Authors' response to Reviewer 1 comments

Figure R1: Comparison of h/L (with $h = 10$ m) and Richardson number calculated for both the near-surface layer (20–50 m; left) and the rotor layer (20–300 m; right) over the wind lease region from the newly-conducted simulation.

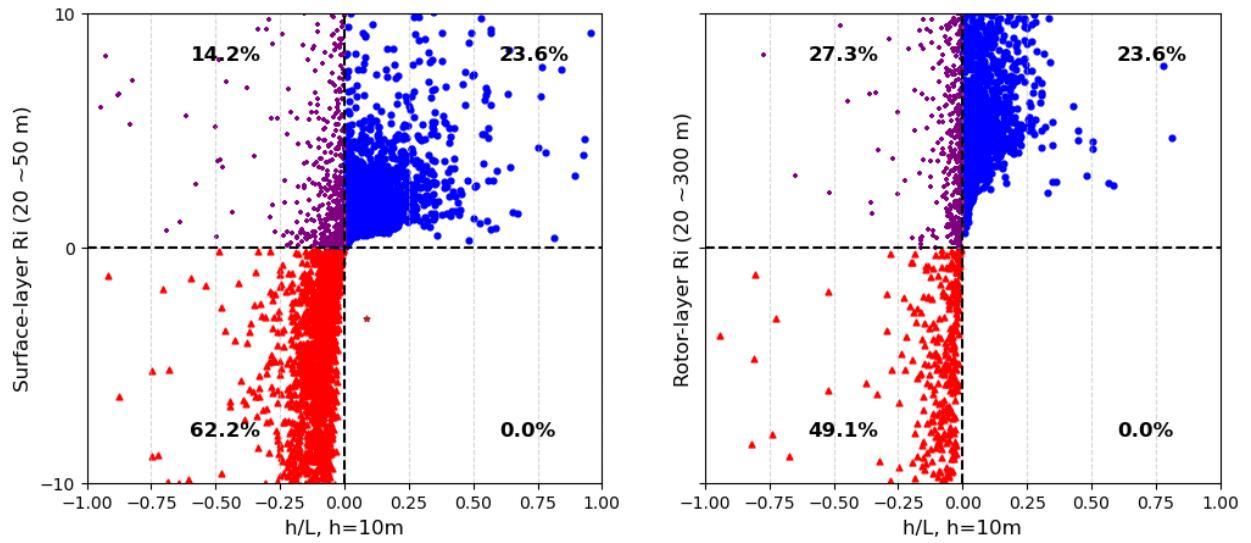
1- One of the most relevant findings in the manuscript relates to stability differences between the surface and the rotor area. This is an important aspect of wake modeling, and I encourage the authors to expand this analysis. Specifically, could you include a comparison with $1/L$ at the surface, which is a standard WRF output and widely used in the literature? Additionally, it would be helpful to investigate whether there is a larger mismatch between Ri at the surface and at rotor height near the shoreline. Please also clarify in the text how stability classes were defined using Ri values, as this is currently only indicated in Figure 4 and Table 3.

Thank you for your comment. Reviewer #3 also raised a similar question. Based on your comment, we have conducted additional simulations to extract the Obukhov length (L) to look into this as we did not output the Obukhov length in our initial study. Figure R1 compares h/L (with $h = 10$ m) against Ri calculated for both the near-surface layer (20–50 m) and the rotor layer (20–300 m) at locations within the wind lease region from the newly-conducted simulation. Over the simulated 1-year period, both stability metrics (L and Ri) agree most of the time, and their agreement improves when Ri is evaluated close to the surface (20–50 m). However, even in that case, approximately 14% of the time, L indicates unstable conditions while the near-surface Ri indicates stable conditions. This discrepancy increases to 28% when compared with rotor-layer Ri . Conversely, there are very few data points where L indicates stable conditions and Ri indicates unstable conditions. These results (in particular, the increase from 14% of points in disagreement to 28% of points in disagreement) demonstrate that surface-based stability (L) does not reliably represent stability in

the rotor layer. Because detailed comparison of Richardson number and Obukhov length is not the focus the scope of this paper, we did not include the corresponding figure in the revised manuscript. However, we have added a discussion on the differences between L and Ri to justify our choice of stability metric.

Lines 252-259: *To examine the difference in stability indication between Obukhov length, L , and Bulk Ri , similar analysis was conducted by comparing h/L (with $h = 10$ m) against Ri calculated for both the near-surface layer (20–50 m) and the rotor layer (20–300 m) over the wind lease region. The results suggested that approximately 14% of the time, h/L indicates unstable conditions while the near-surface Ri indicates stable conditions. The discrepancy increases to 28% when compared with rotor-layer Ri . These results further suggest that surface-based stability does not reliably represent stability in the rotor layer. Therefore, for the remainder of the paper, we will use the rotor-layer Ri for further analysis, as it is more appropriate for examining the effects of stability on the wind turbines. However, we note that defining stability in this manner has limitations, particularly when strong local inhomogeneity exists within the rotor layer (e.g., coastal low-level jets).*
